AIR - INCORPORATE A NON-RETURN VALVE INTO THE LPC BLEED-MASTER ACTUATOR LP RETURN LINE  
- CATEGORY CODE 4 - MOD.ENG-75-0019

**V2500-ENG-75-0019**

1666-75-001

ENGINE COMPRESSOR CONTROL - LPC BLEED -  
MASTER ACTUATOR - INTRODUCTION OF  
RETURN PORT NON-RETURN VALVE

Location of the LPC Bleed-Master Actuator  
Fig.1

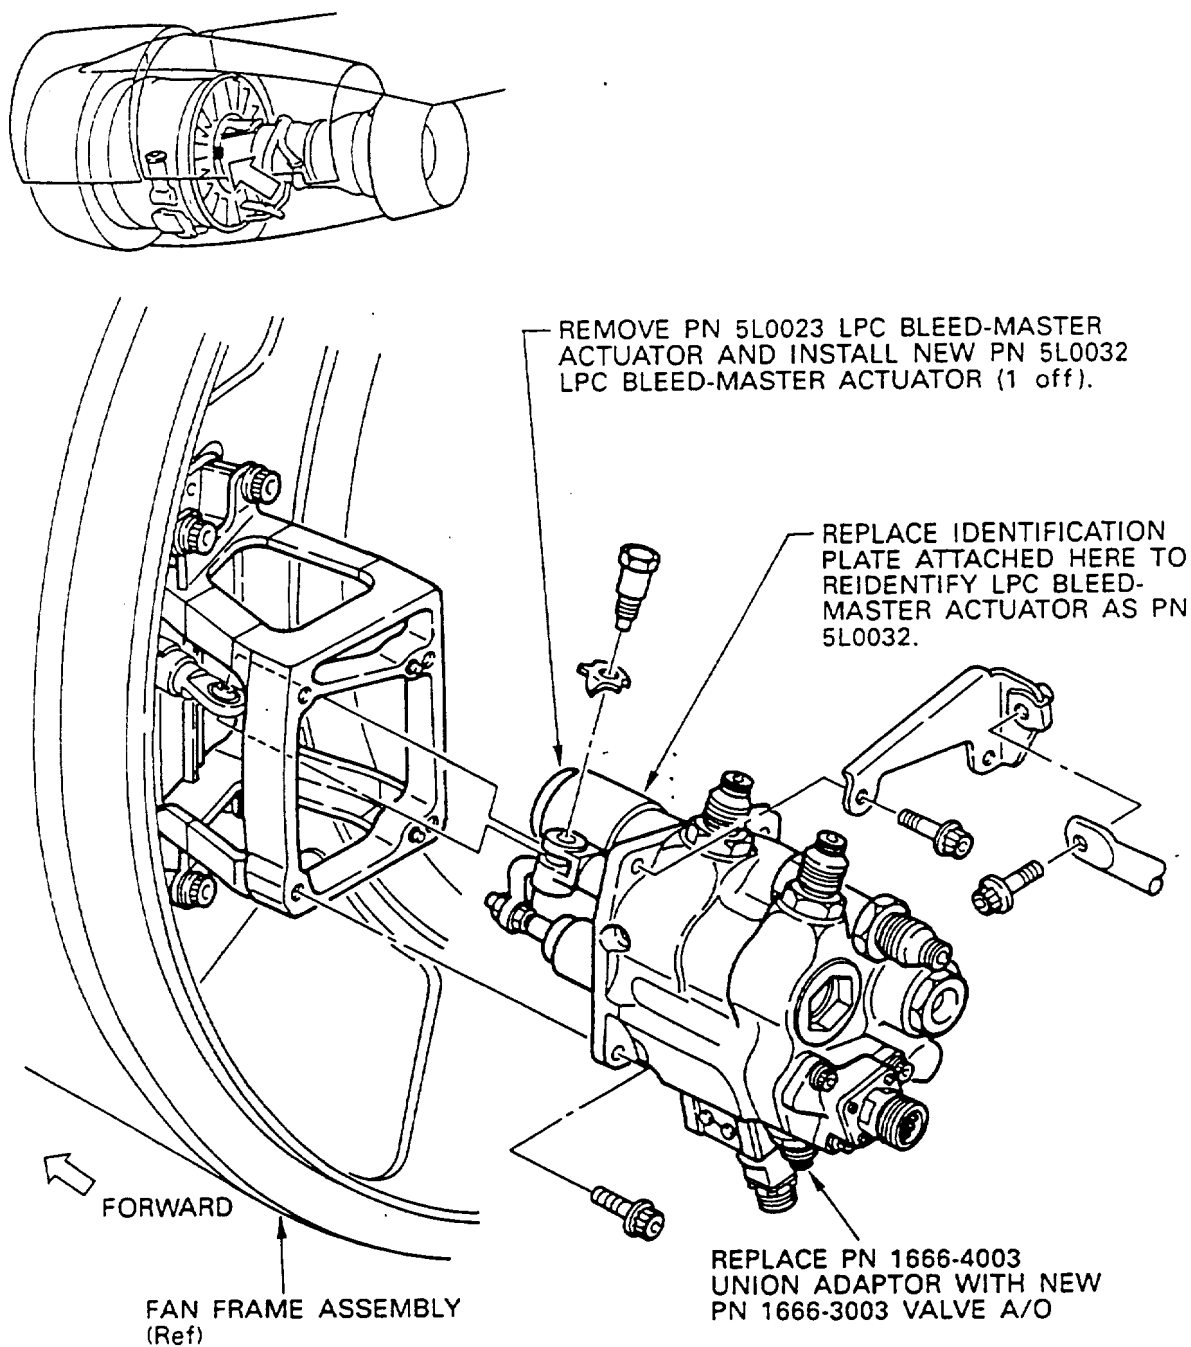
(a) A Union Adaptor which is fitted in the LP return port of the LPC Bleed-Master Actuator has been changed with a Non-return Valve A/O (See Figure 1).

(b) Existing Part Number of LPC Bleed-Master Actuator has been changed to a new Part Number (See Figure 1).

Assembling the Non-return Valve  
Figure 1

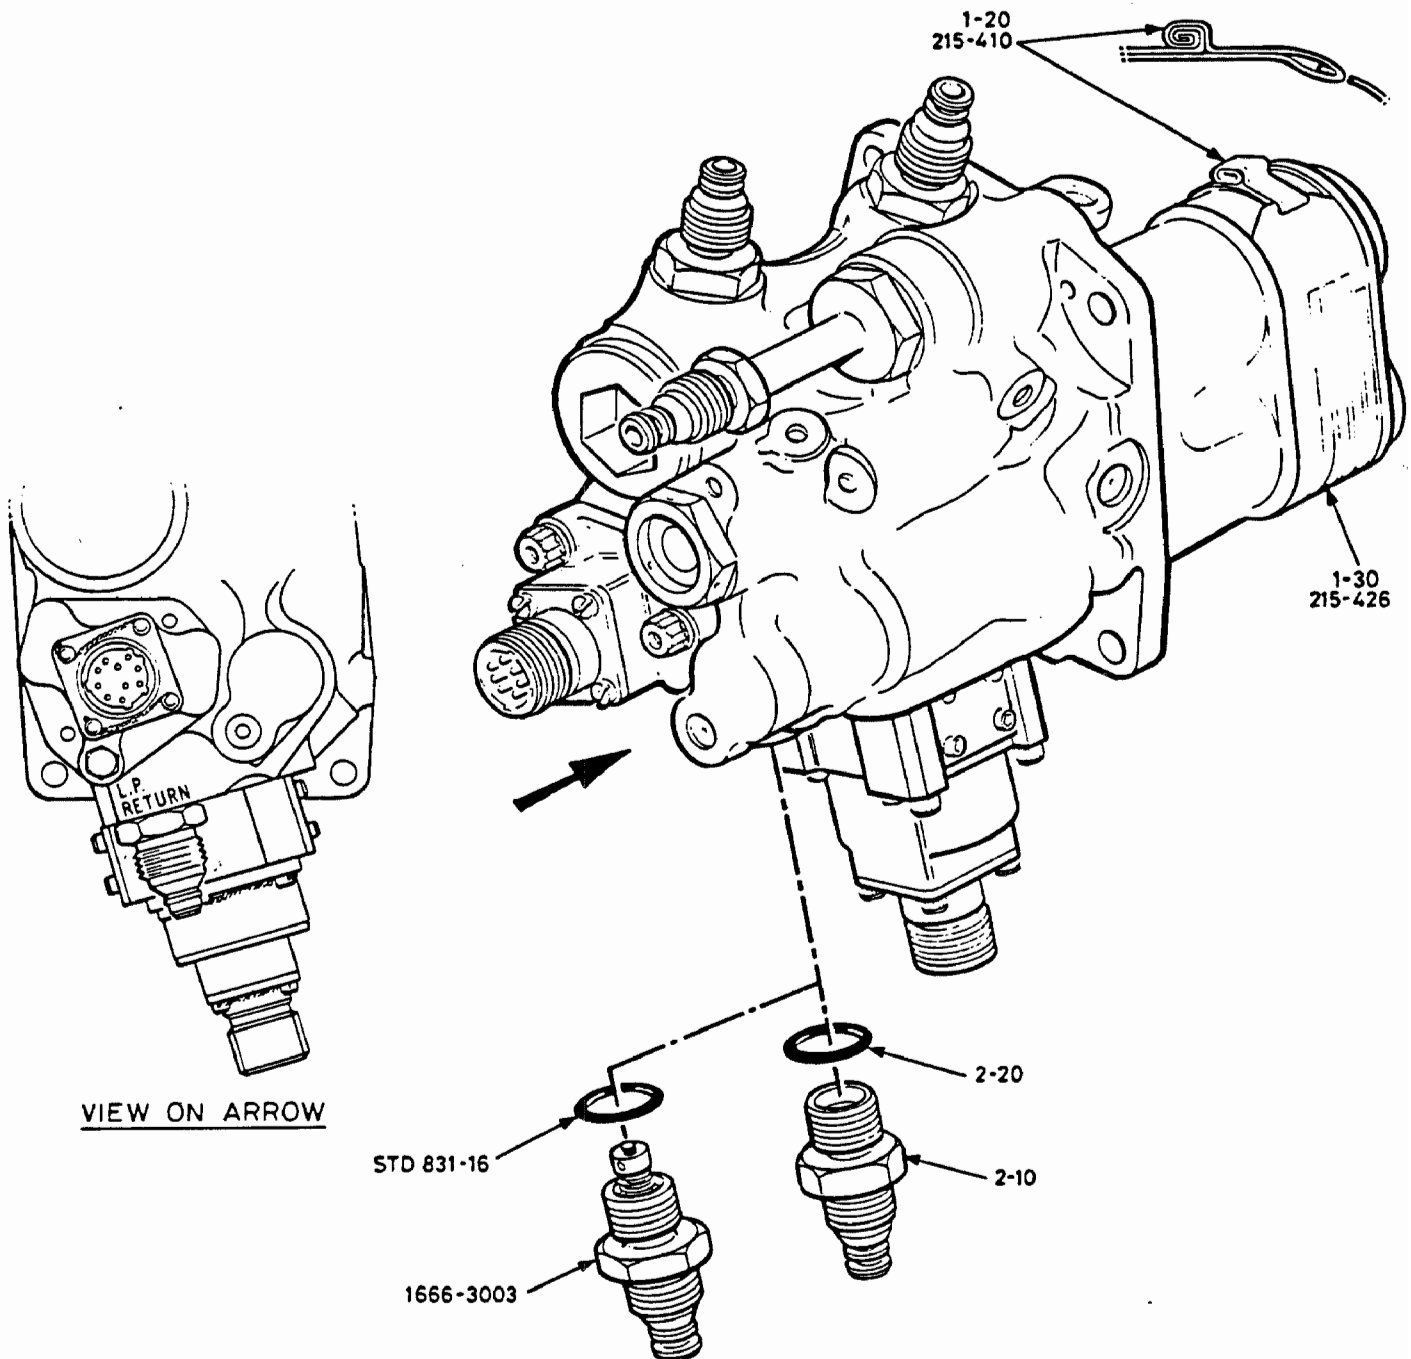
#### B. Install the Non-Return Valve (Figure 1)

- (1) Loosen and remove the union adaptor (2-10) from the Actuator connection marked 'LP RETURN'; remove the sealing ring (2-20).
- (2) Install the new toroidal sealing ring STD831-16 (supplied with the Mod. kit), to the non-return valve assy. 1666-3003.
- (3) Assemble the non-return valve assy. 1666-3003 to the Actuator connection marked 'LP RETURN'; torque tighten the non-return valve assy. to 300 lbf.in. (34 Nm).
- (4) Release the strap (1-20) which secures the identification plate (1-30) and remove the strap and the identification plate; keep the identification plate but discard the strap.
